METROPOLITAN GOVERNMENT OF NASHVILLE AND DAVIDSON COUNTY

STAFF RECOMMENDATION 1921 19th Avenue South October 21, 2015

Application: New construction- outbuilding; Setback determination
District: Belmont-Hillsboro Neighborhood Conservation Zoning Overlay
Council District: 18
Map and Parcel Number: 10412017200
Applicant: Lynn Taylor
Project Lead: Melissa Sajid, Melissa.sajid@nashville.gov

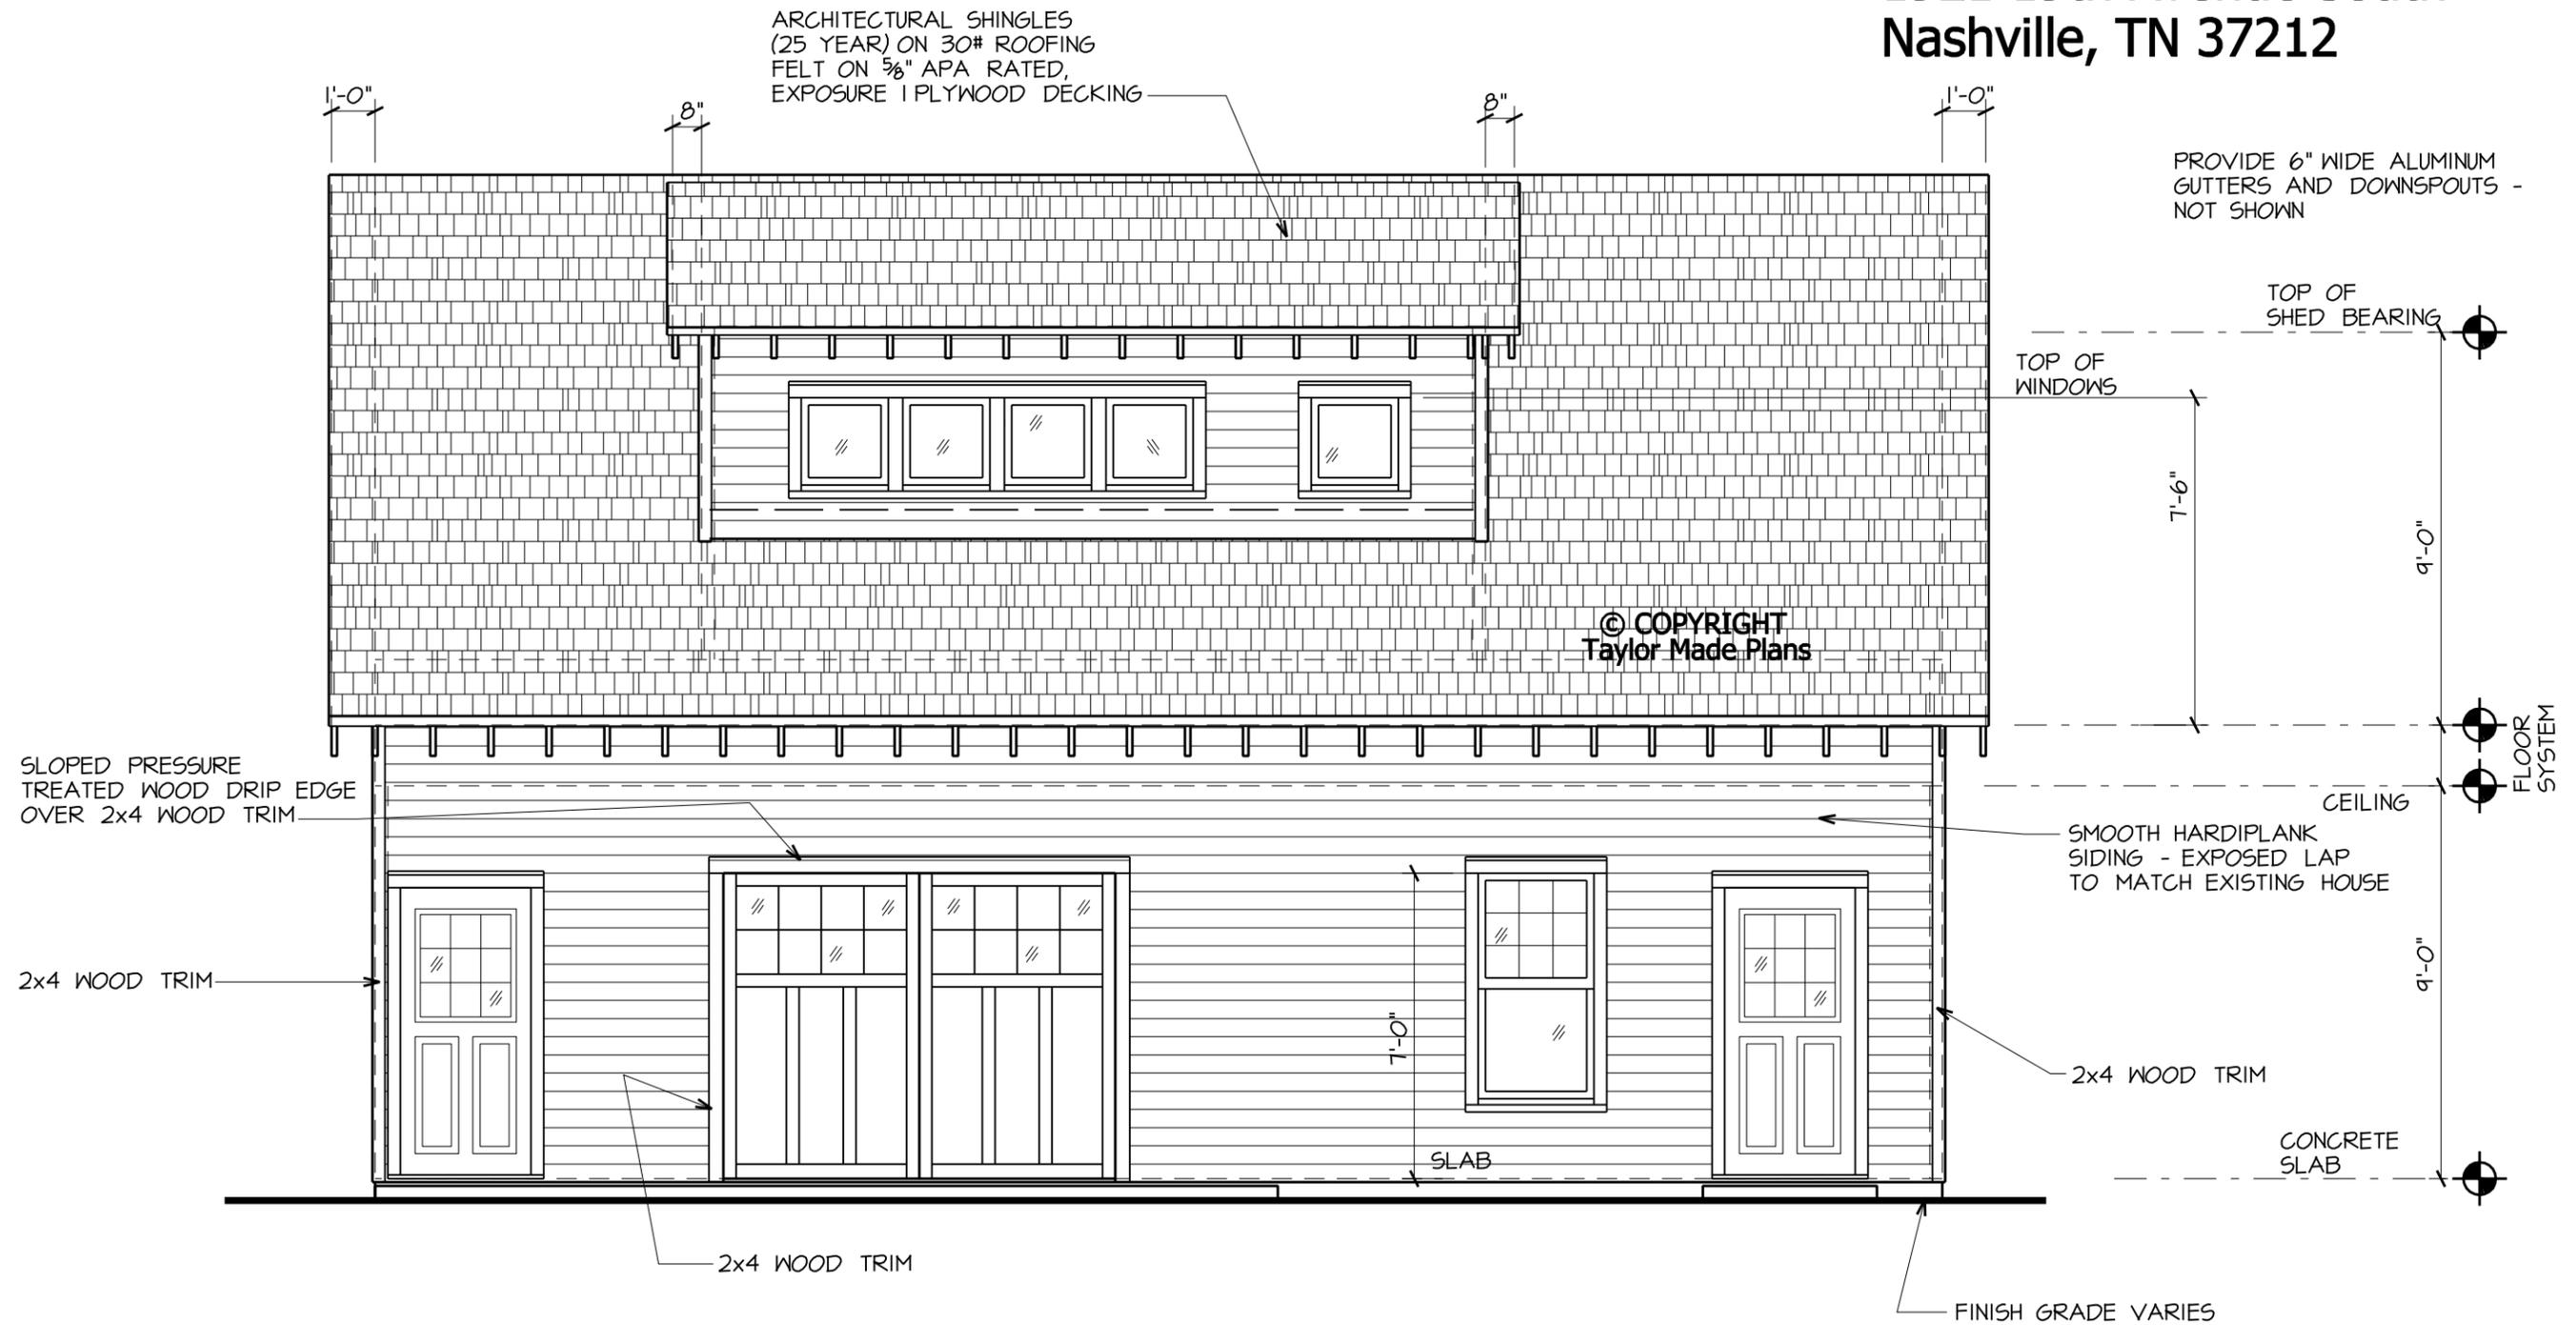
Location, Setback: The proposed accessory structure will be located behind the existing house in the rear yard. The garage will be accessed via the alley and the existing driveway, with garage doors located on the front and rear façades. The garage meets the base zoning requirement for the rear setback but not for the side setback. The structure is proposed to be situated three feet (3') from the left property line and ten feet (10') from the rear property line. The Zoning Code requires a minimum side setback of five feet (5') in the R8 district, and the side setback may be reduced to three feet (3') for accessory structures that are seven hundred square feet (700 SF) or less.

The reason for the setback determination request is because to continue to use the existing driveway, as well as the alley, requires an odd angle for parking. There is the option of abandoning the driveway, since alley access exists or relocating the staircase in the building, so that the driveway access is straighter.

As the proposed outbuilding exceeds the size of a typical outbuilding and will be converted to a DADU, because there are other options than what is proposed and because the lot is larger than the standard lot with both street and alley access, staff recommends

that the outbuilding comply with the required side setback. Staff finds that, with this condition, the location and setbacks for the proposed accessory structures meet Section II.B.c. and II.B.i. of the design guidelines.

1. Staff approve the final details, dimensions and materials of windows, doors and garage doors and roof color prior to purchase and installation; and,
2. Increase the left side setback to five feet (5').

1 FRONT ELEVATION
SCALE: 1/4" = 1'-0"

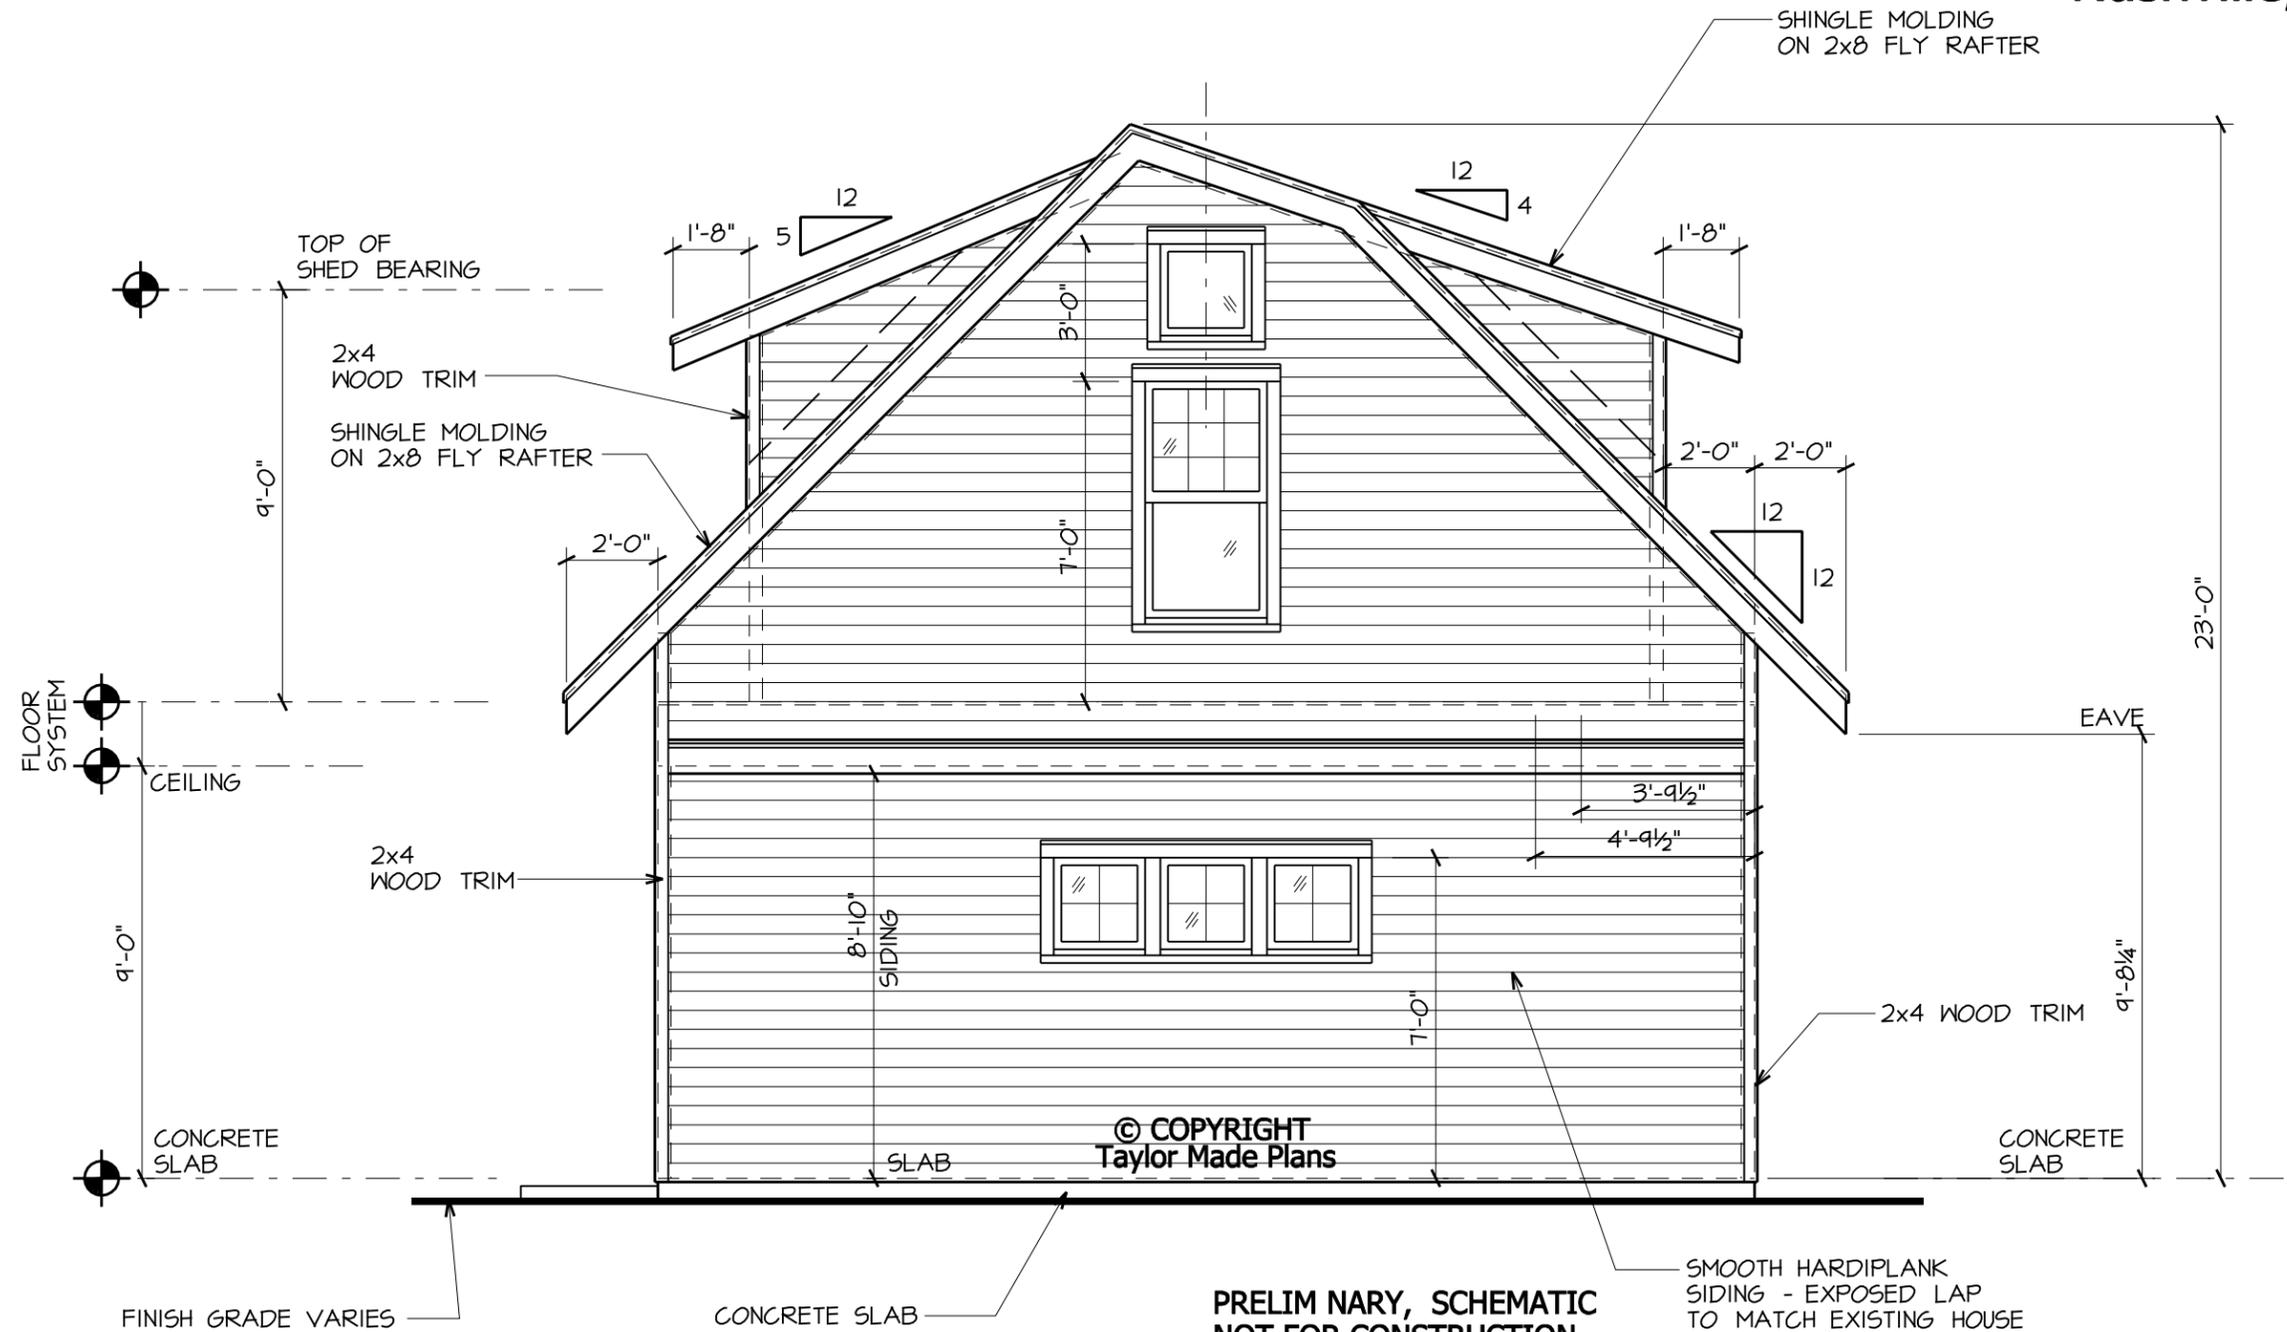
Materials: The proposed materials include smooth-faced cement-fiber siding with a five inch (5") exposure for the primary and dormer field cladding. The roof will be architectural shingles. The color was not indicated so staff recommends administrative approval of the roof color. The foundation will be a concrete slab. The corner boards and trim will be wood. The materials for the windows and doors were not specified, and staff asks to approve the final materials and specifications for all windows and doors prior to purchase and installation. With the recommended conditions, staff finds that the structure's materials meet Sections II.B.d. and II.B.i. of the design guidelines

Roof Form: The structure's primary roof form is a side gable roof with a slope of 12/12. The front and alley-facing façades each have a shed dormer with a slope of 4/12. The dormers are setback two feet (2') off the wall below and do not encompass more than fifty percent (50%) of the roof. Staff finds that the roof form is compatible with that of the house and with surrounding historic structures, and meets Sections II.B.e. and II.B.i. of the design guidelines.
